SURVEY FOR
OAK & STONE CUSTOM HOMES

LOT 155, THE OAKS AT IRONWOOD
3403 RIVER MANOR COURT
PIN# 1825.00-44-8659
REF: D.B. 1914, PAGE 308
REF: P.B. 51, PAGE 64

storm water Approved! Linda R. Spelt, Planner, 10/23/2023

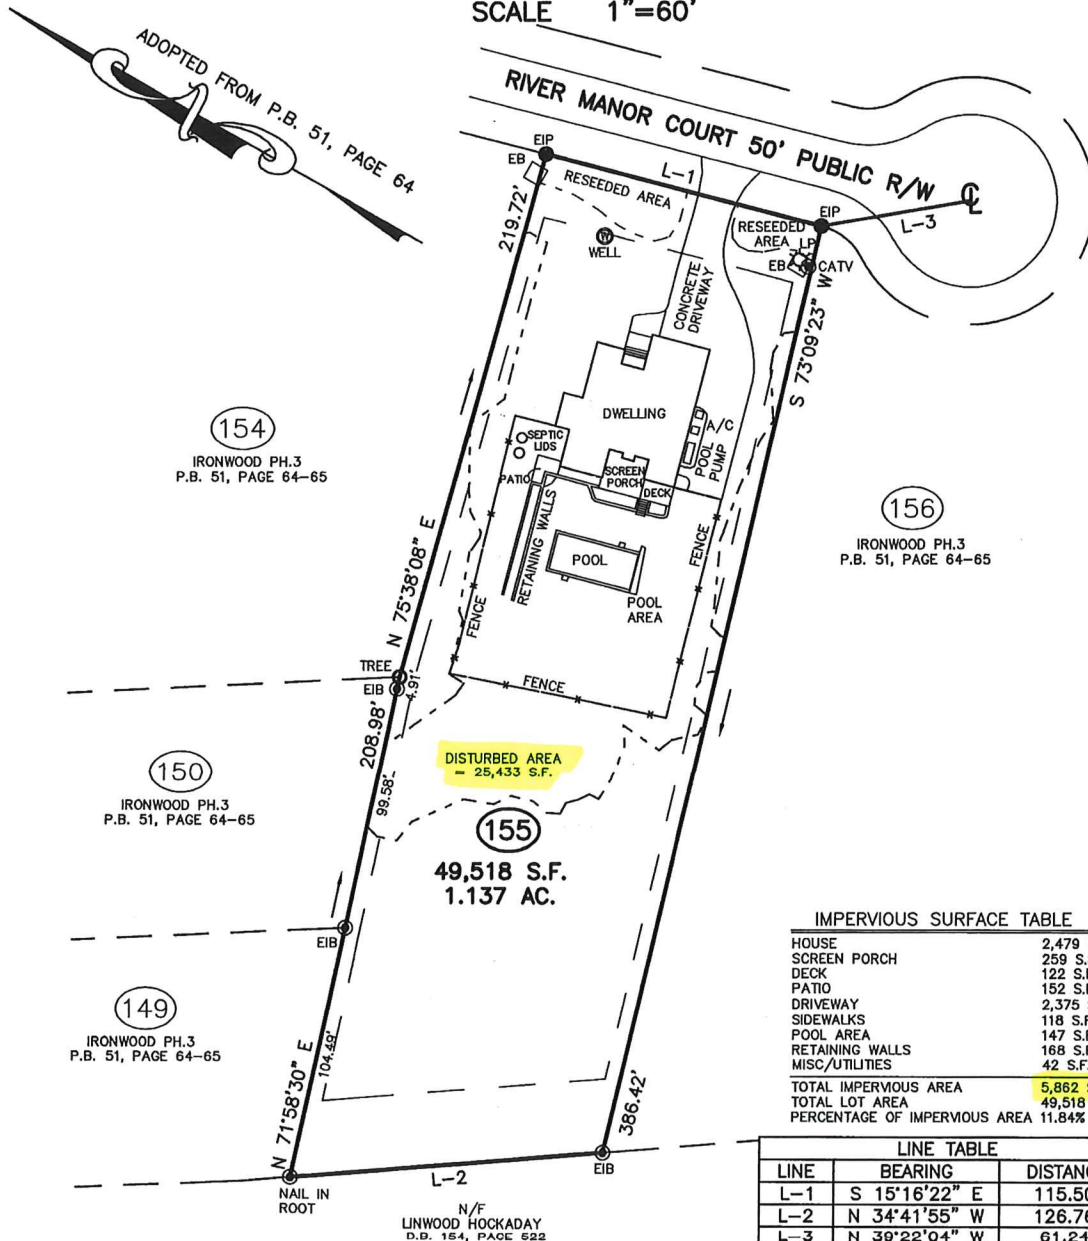
storm water plan allows: 27,650 disturbance (cleaning)
6,400 BUA
